MEMORANDUM

TO: Water Right File 61-7731

FROM: Daniel Nelson – Analyst 3

SUBJECT: Licensing Review of Water Right 61-7731

This map shows the point of diversion and place of use of the Snake Pit (Site 3) which was not included in Mr. King's field report. However, since it was in the 1999 recharge event, it needs to be included in this permit.

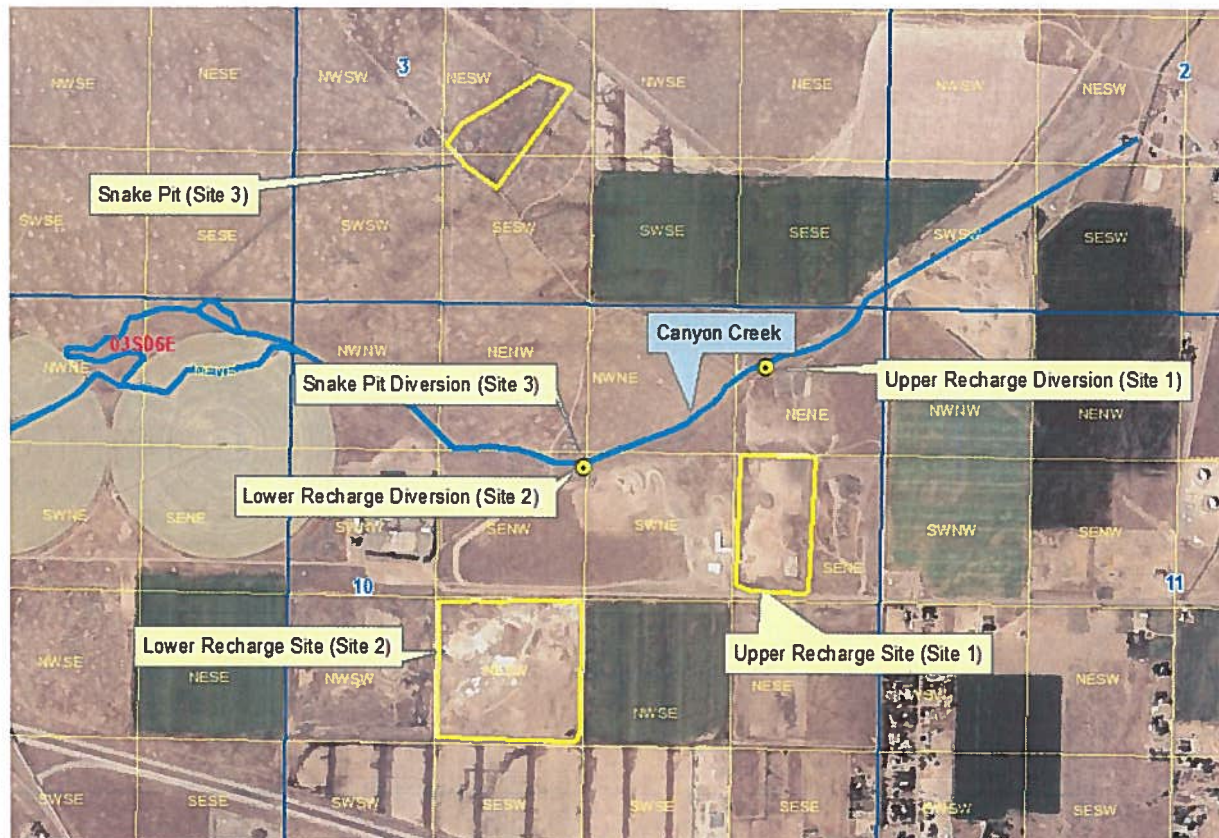
Mr. King provided an excellent map of the place of use for the two gravel pit recharge sites. However, Mr. King didn't provide a map of the third recharge site on the north side of the creek. Therefore, this place of use will be added to the permit. Site 3 wasn't included on the permit either, so this site will need to be added to the amendment. I have attached a map to the memo to show the place of use and points of diversion for each of the sites. Site 3 is located in the NESW and SESW of Section 3, Township 3 South, Range 6 East.

FIELD NOTES MAP FROM 1999 RECHARGE PROJECT FILE

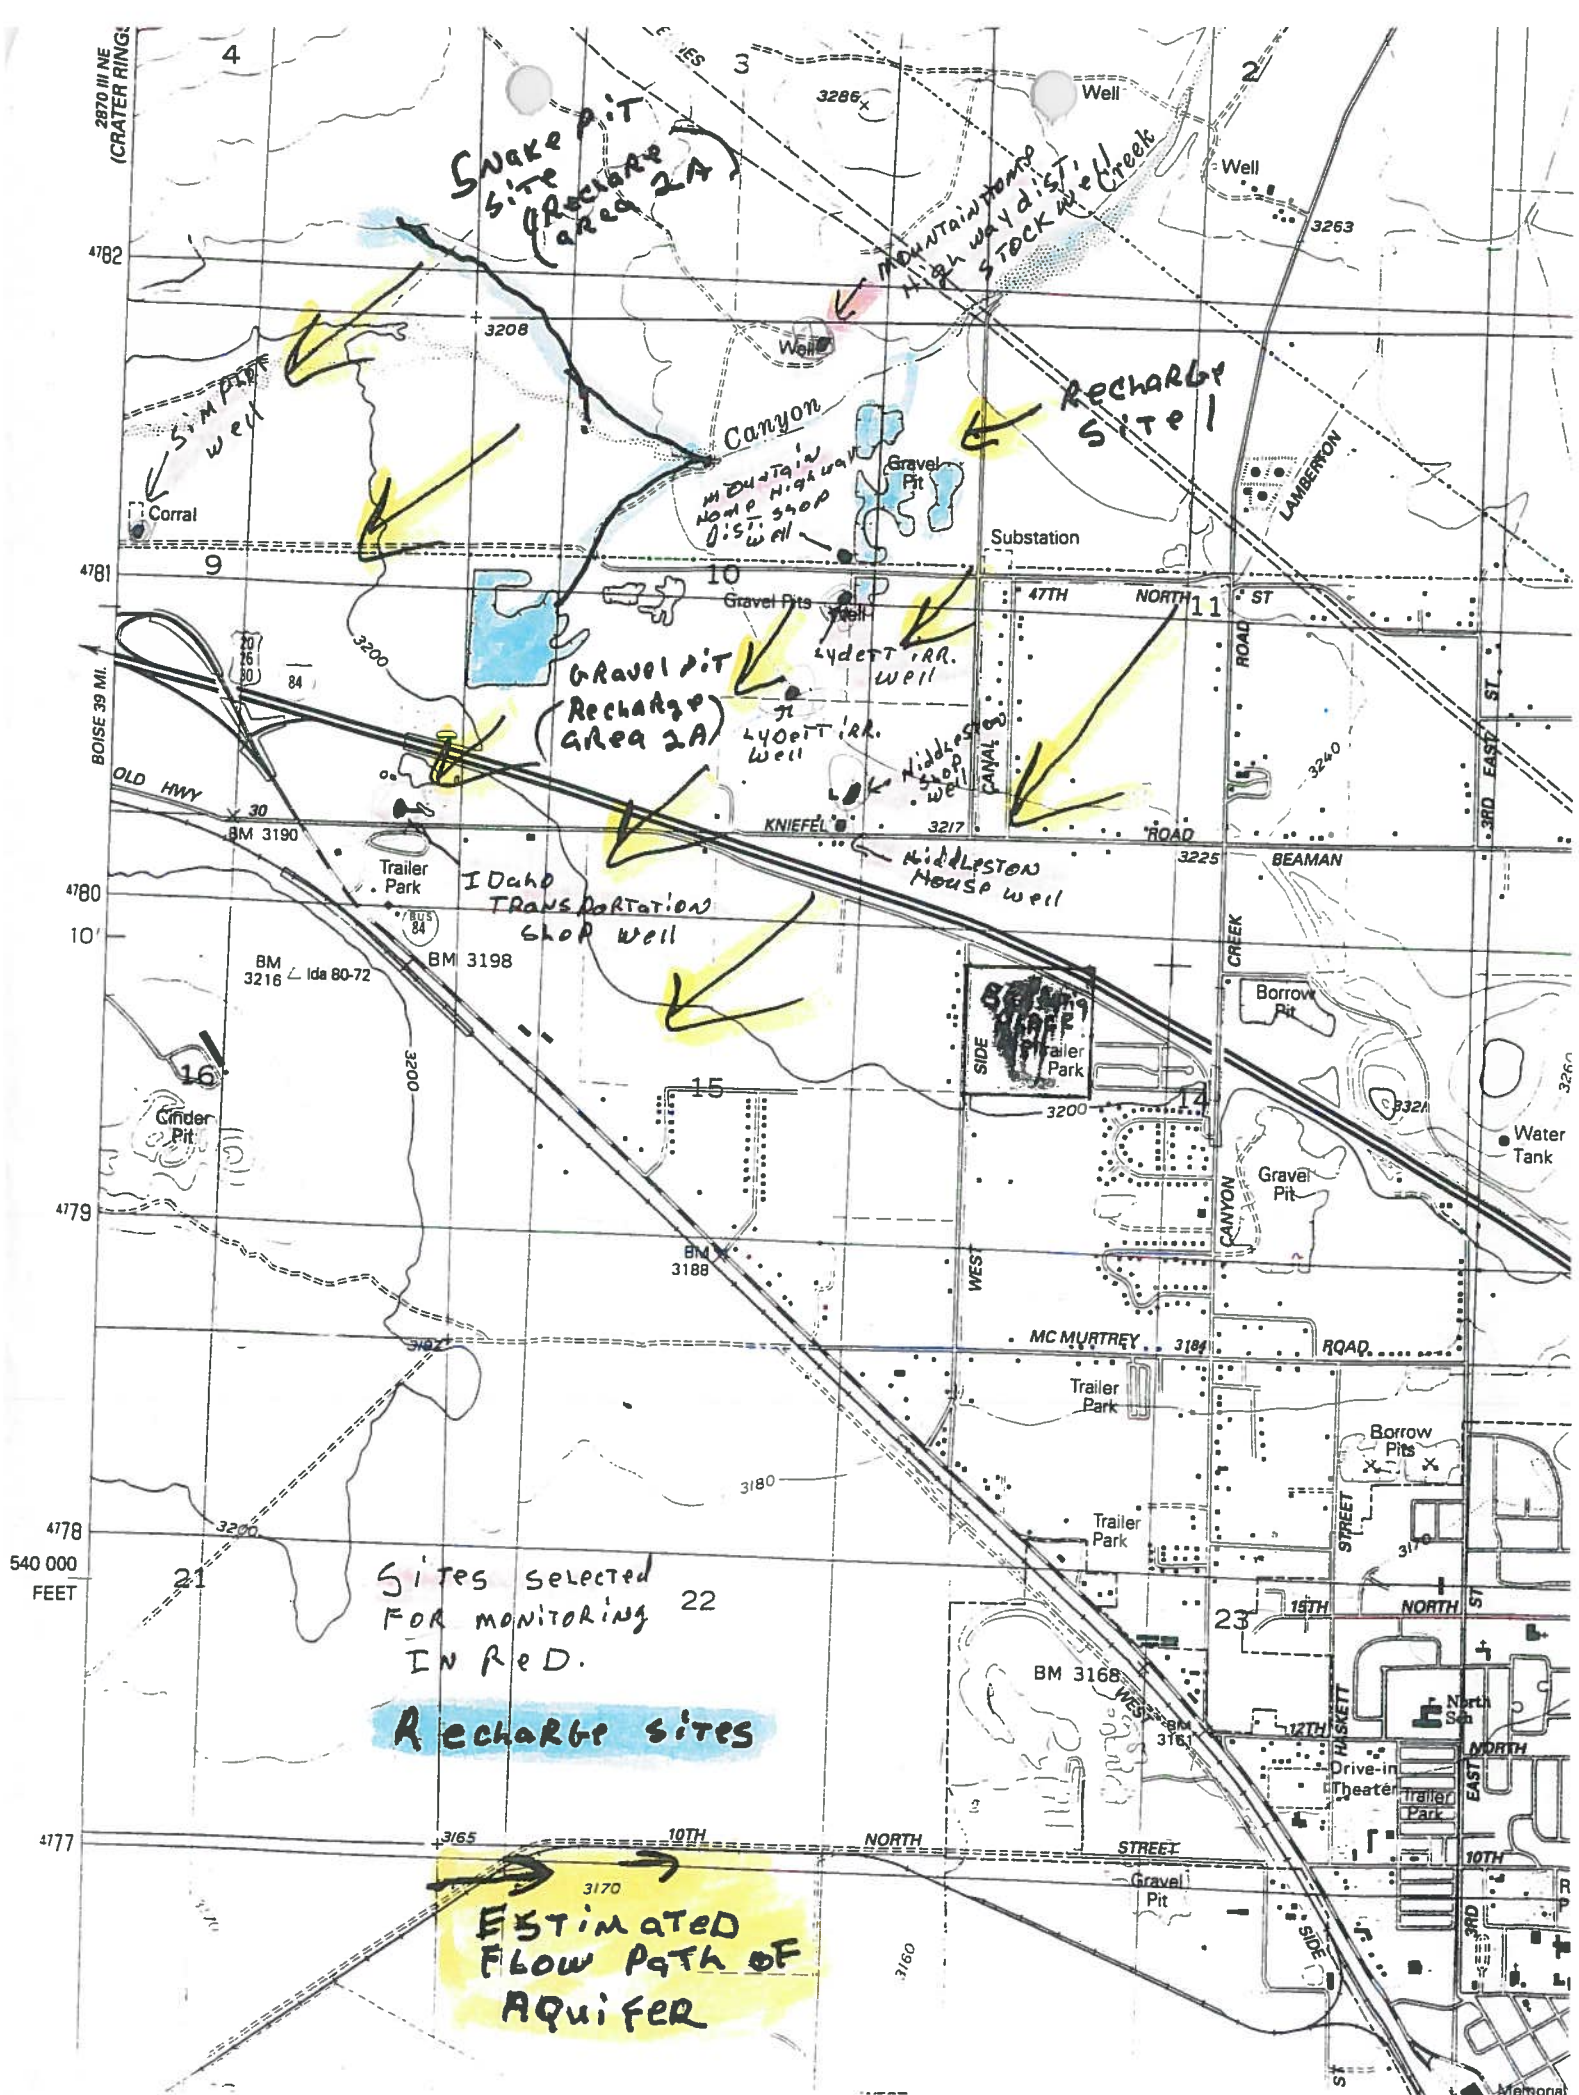
Mr King GPS'ed the two points of diversion and properly located them on the map. According to the 1999 report there were actually three points of diversion. The diversion not located in Mr. King's report diverted into a ditch that meandered north from the creek to a location known as the snake pit. That ditch was dirt channel created specifically for the 1999 recharge event and appears to no longer exist. Regardless of what is being done at the present time, we will need to list all three points of diversion on the permit. This will allow us to properly split the permit at licensing.

The lower diversion in the SENW of Section 10, Township 3 South, Range 6 East, was not included on the permit. Therefore, an amendment of permit will be required before this permit can be licensed.
